Landscape and Visual Assessment - Review

Beckermeth Wind Turbine

Cumberland Borough Council

Galpin Landscape Architecture

Figure 5.1 Steps in assessing landscape effects

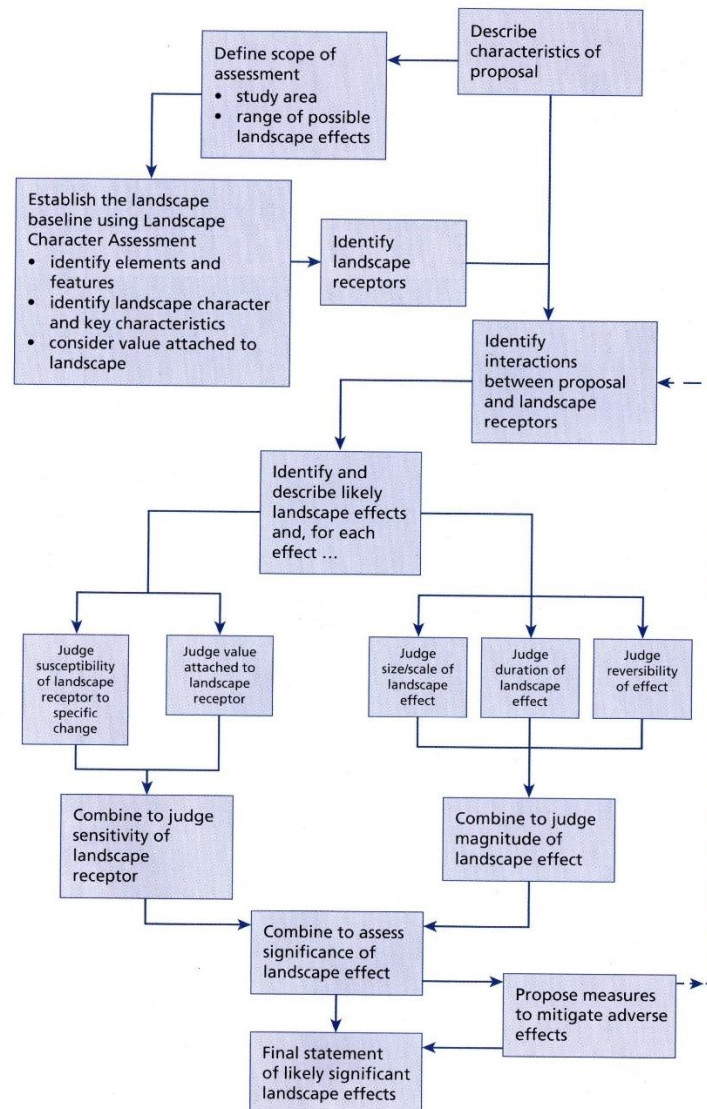
- 2.40 In 'Figure 5.1' above (taken from GLVIA3), the steps in assessing the landscape effects are demonstrated. The submitted LVIA assessment fails to correctly combine judgements of magnitude of effect and sensitivity to assess the significance of effect. It fails to do this for the landscape receptors and those identified as residential and route receptors which would follow a largely similar methodology.
- 2.41 Section 7.2 of the submitted LVIA states, 'All properties are assessed as having a High sensitivity to change', however, the sensitivity of the Property Groups is then
